RIVERVIEW PLACE SUBDIVISION

The purpose of this application is to create a thirteen-lot subdivision from two metes and bounds parcels.

APPLICATION NUMBER 18 DATE June 19, 2003

SUBDIVISION PLAT

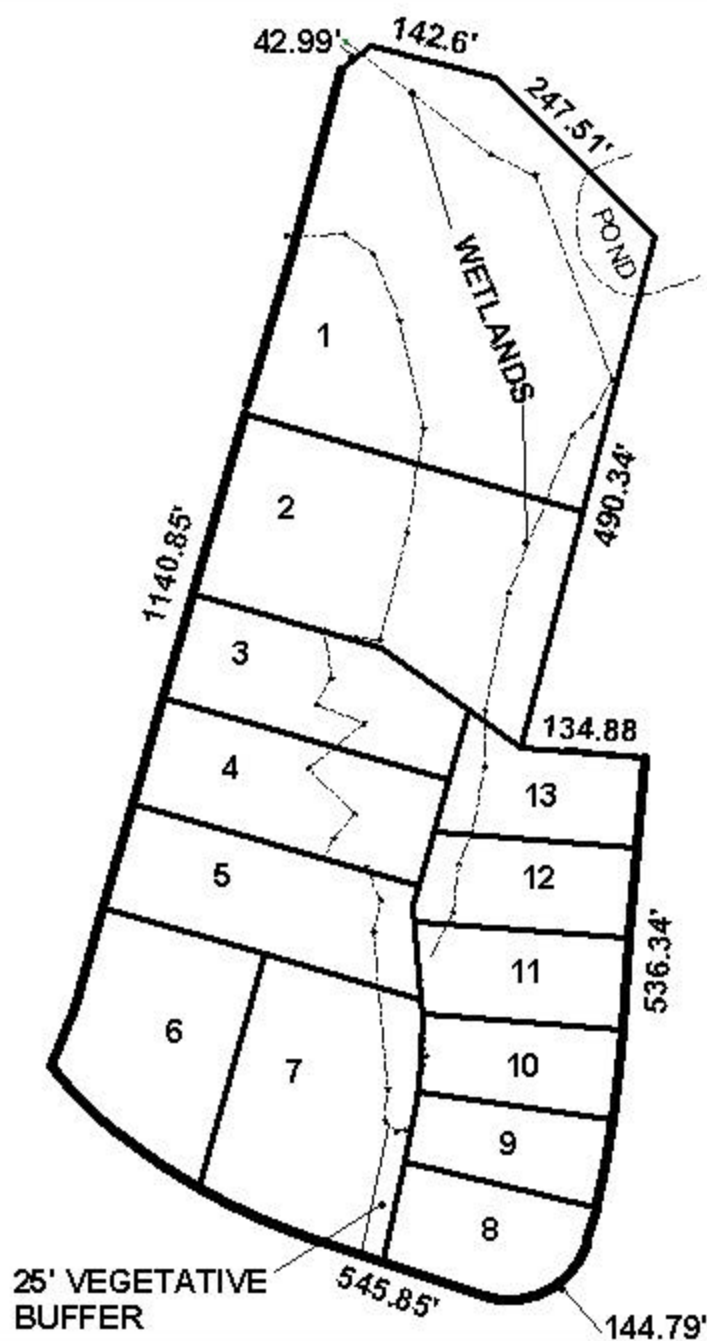
The site fronts Dauphin Island Parkway, which is a major street on the Major Street Plan has an existing right-of-way in compliance with the Plan. With Lots 1-6 having access on Marina Drive South, which serves as a service road for this portion of Dauphin Island Parkway, access management is not a major concern; however, Lot 6 should be limited to one curb cut to Marina Drive South.

It is likely that Lots 1-6 will be developed as commercial, thus a note should be placed on the final plat stating that any lots which are developed commercially and adjoin residentially developed property must provide a buffer, in compliance with Section V.A.7. of the Subdivision Regulations.

The proposed subdivision would create five new lots along Bay Road North, which is gravel; therefore, this portion of Bay Road North should be paved to County Standards, along the entire frontage of Lots 8-13.

The 25-foot minimum building setback line is not shown but would be required on the final plat.

With modifications, the plat will meet the minimum requirements of the Subdivision Regulations and is recommended for Tentative Approval subject to the following conditions: 1) the placement of a note on the final plat stating that Lot 6 is limited to one curb cut to Marina Drive South, with the size, location and design to be approved by County Engineering; 2) the placement of a note on the final plat stating that any lot that is developed commercially and adjoins residentially developed property shall provide a buffer, in compliance with Section V.A.7. of the Subdivision Regulations; 3) that Lots 9-13 not be recorded until the existing Bay Road North is paved to County standards along the entire frontage of Lots 8-13; 4) the approval of all applicable federal, state, and local agencies; and 5) placement of the required 25-foot minimum building setback line on the final plat.
